New Hanover County Department of Juvenile Justice

CM Clarification #2

Date: June 6, 2019

Project: New Hanover County Department of Juvenile Justice

E2.1.1

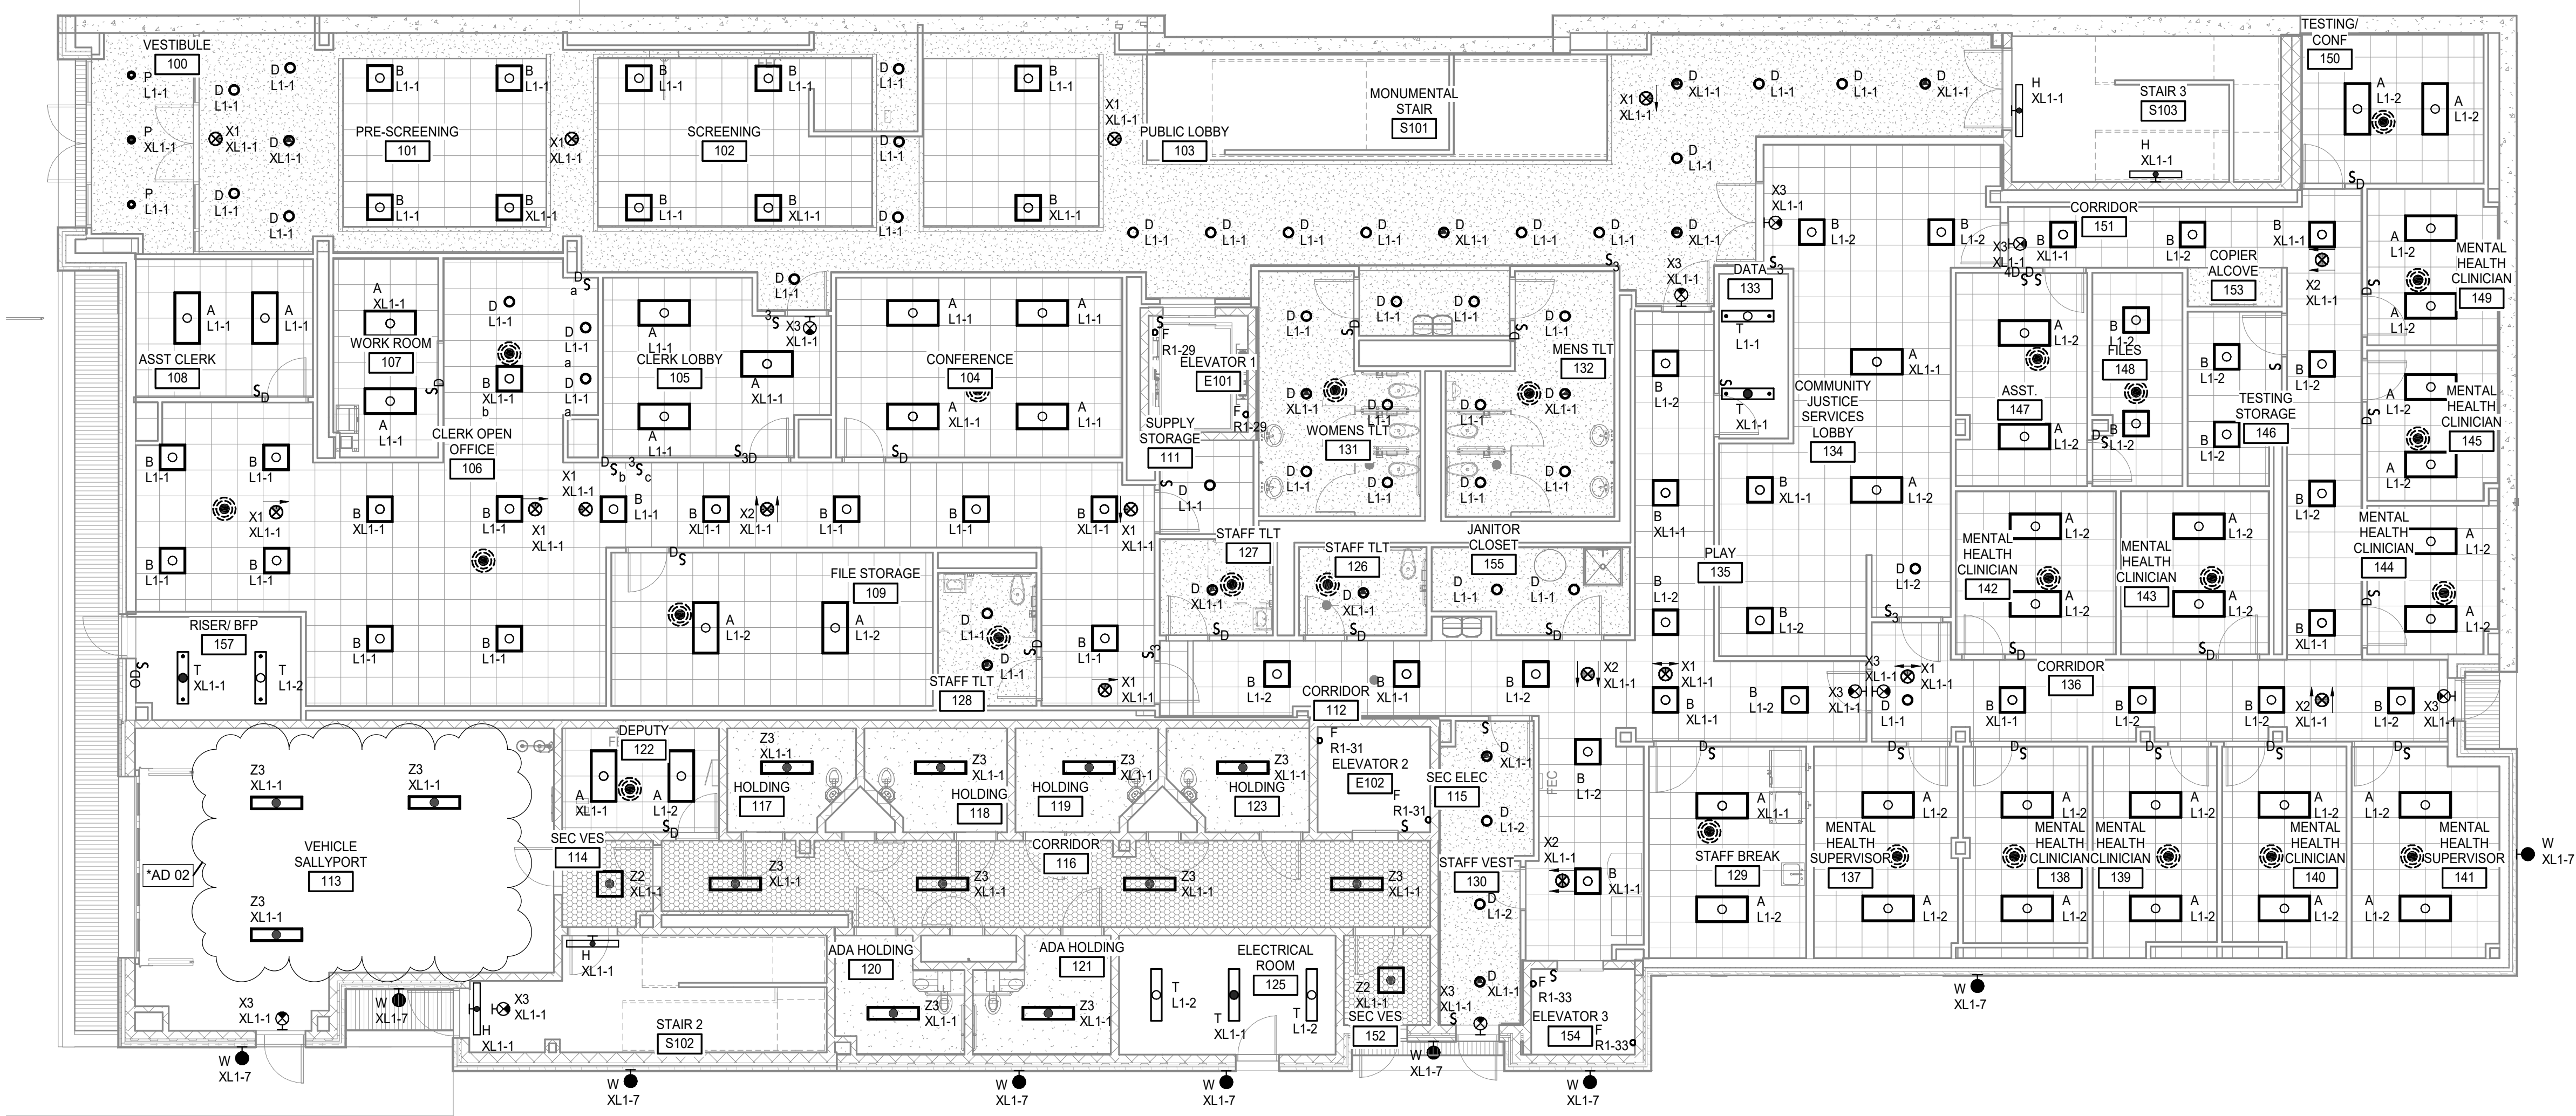
Item 16: Electrical; attached are revised sheets E1.0, E2.1.1, and E5.1 providing clarification on the emergency generator, sally port lights, and power one-line diagram
